SUBJECT: MONTICELLO NUCLEAR GENERATING PLANT - STAFF ASSESSMENT OF INFORMATION PROVIDED PURSUANT TO TITLE 10 OF THE *CODE OF FEDERAL REGULATIONS* PART 50, SECTION 50.54(f), SEISMIC HAZARD REEVALUATIONS FOR RECOMMENDATION 2.1 OF THE NEAR-TERM TASK FORCE REVIEW OF INSIGHTS FROM THE FUKUSHIMA DAI-ICHI ACCIDENT (TAC NO. MF3958)

STAFF ASSESSMENT BY THE OFFICE OF NUCLEAR REACTOR REGULATION

RELATED TO SEISMIC HAZARD AND SCREENING REPORT

MONTICELLO NUCLEAR GENERATING PLANT

Figure 3.3-1 Plot of Staff's and Licensee's Base Case Shear-Wave Velocity Profiles for the Monticello Site

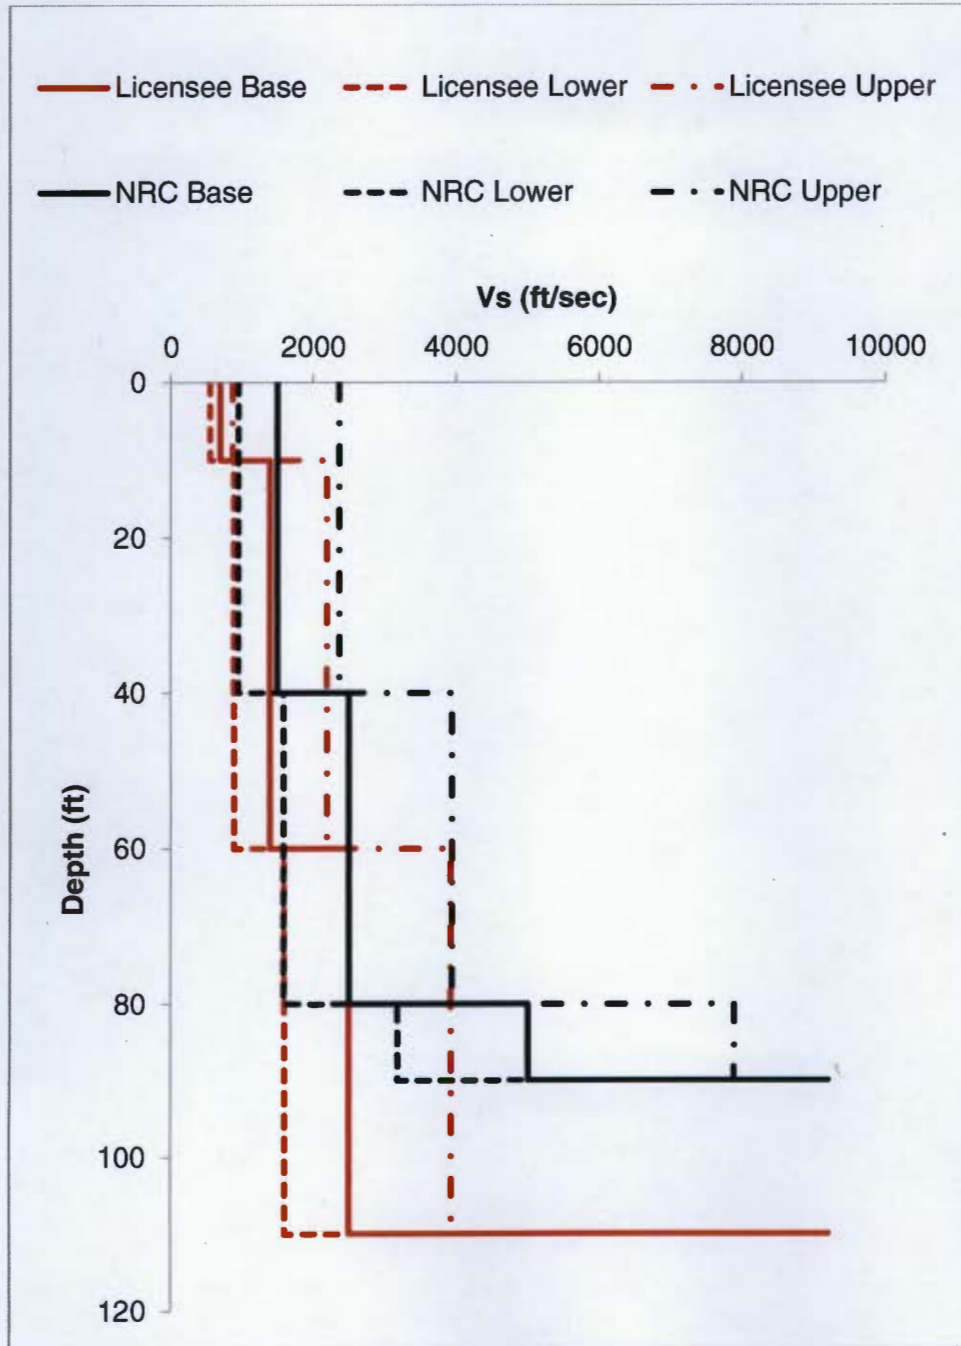
The staff performed independent calculations to confirm that the licensee's amplification factors and control point hazard curves adequately characterize the site response, including the uncertainty associated with the subsurface material properties, for the Monticello site. The staff independently developed three base case shear-wave velocity profiles from information provided in the USAR. The staff's base case shear-wave velocity profiles are shown along with the licensee's base case profiles in Figure 3.3-1 of this assessment. The staff's shear wave velocity profiles agree with those submitted by the licensee with only a minor difference in the estimated depth to bedrock.

Figure 3.3- 1 Plot Comparing the Staff's and the Licensee's Median Amplification Functions and Uncertainties for the Monticello site.

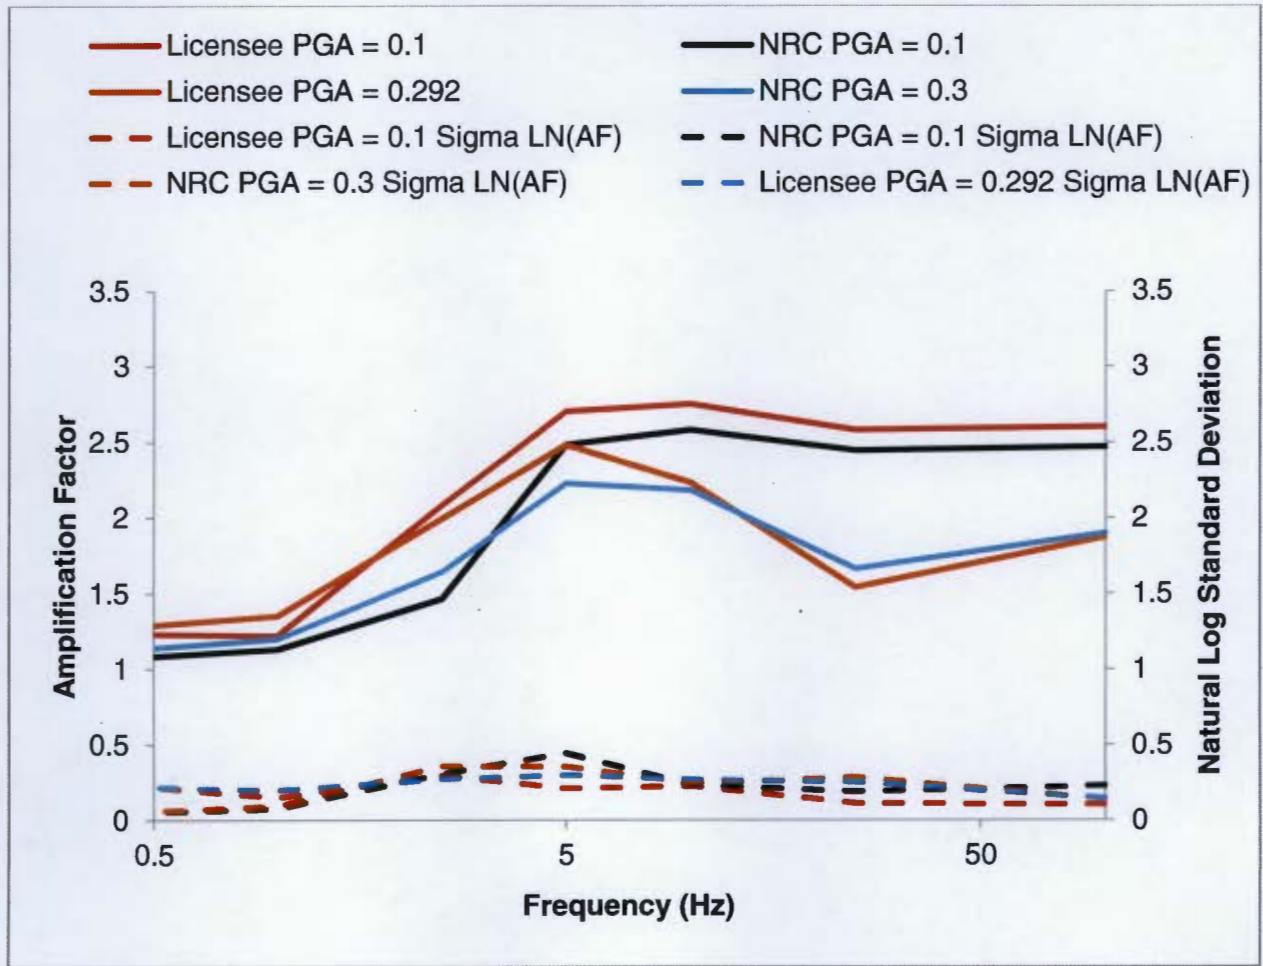
In order to calculate control point hazard curves for the Monticello site, the licensee and staff developed median amplification functions for the site for several different loading levels, representing the possible hazard at the Monticello site. The licensee's and staff's median site amplification functions and associated uncertainty for two separate loading levels are shown in Figure 3.3-2 of this assessment. It can be seen that both the staff's and licensee's site amplifications are similar in shape with only a slight differences for the higher frequencies. Figure 3.3-3 of this assessment shows the licensee's and staff's control point hazard curves resulting from the convolution of the site amplification with the PSHA rock hazard curves. As shown in Figure 3.3-3, the licensee's and staff's results are very similar.

Figure 3.4-1 Comparison of the Staff's GMRS with Licensee's GMRS and the SSE for the Monticello site

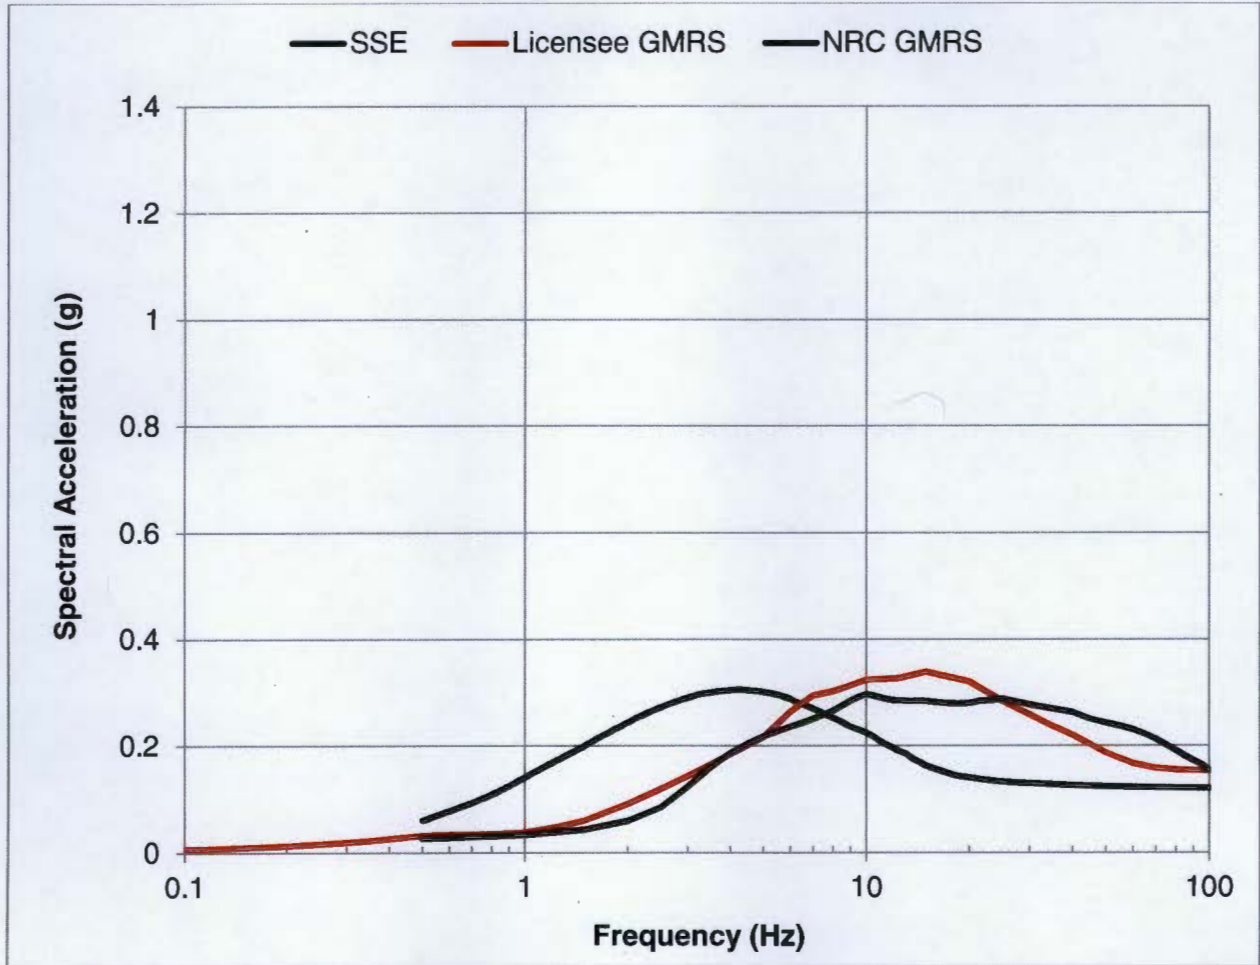
The NRC staff independently calculated the 10^{-4} and 10^{-5} UHRS using the results of its confirmatory PSHA and site response analysis, as described in Sections 3.2 and 3.3 of this staff assessment, respectively. Figure 3.4-1 of this assessment shows a comparison of the GMRS determined by the licensee to that determined by the staff. As shown in Figure 3.4-1 below, the licensee's GMRS shape is generally similar to that calculated by the staff. At frequencies where the amplitude of the GMRS determined by the licensee is different from that determined by the staff, the licensee's generally exceeds that of the staff. These differences in GMRS are the result of differences in the site response analyses performed by the licensee and staff as discussed in Section 3.3 above. The NRC staff concludes that these differences are acceptable for this application because the licensee followed the guidance provided in the SPID with respect to both the PSHA and site response analysis for the Monticello site.

In reaching this determination, the NRC staff confirmed the licensee's conclusion that the licensee's GMRS exceeds the SSE for the Monticello site in the frequency range of 1 to 10 Hz, and also in the frequency range above 10 Hz. As such, a seismic risk evaluation, SFP evaluation and high-frequency confirmation are merited. The licensee indicated that the high frequency confirmation would be performed as part of its seismic risk evaluation. The NRC review and acceptance of the NSPM plant seismic risk evaluation with the high frequency confirmation, and also an interim ESEP evaluation and SFP evaluation (i.e., Items (4), (6), (8), and (9)) for Monticello will complete Seismic Hazard Evaluation identified in Enclosure 1 of the 50.54(f).
